PCN / EOL Notification

Product Change Notification Number: CC120905

Title: 32-Kbit Two-wire interface Automotive Grade (-40C to 125C) Serial EEPROM (AT24C32A) Process Geometric Shrink and Device Enhancement

AT24C32D: Package Marking Information

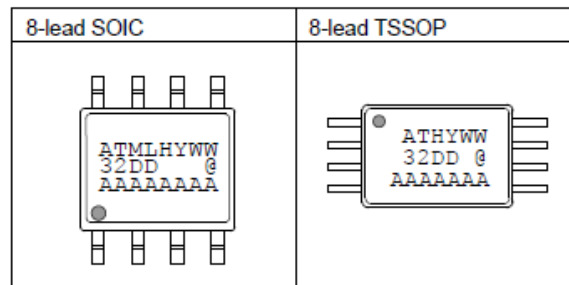
NEW catalog part numbers use "D" suffix for the device revision (AT24C32A changes to AT24C32D). Please refer to Attachment A for part marking scheme.
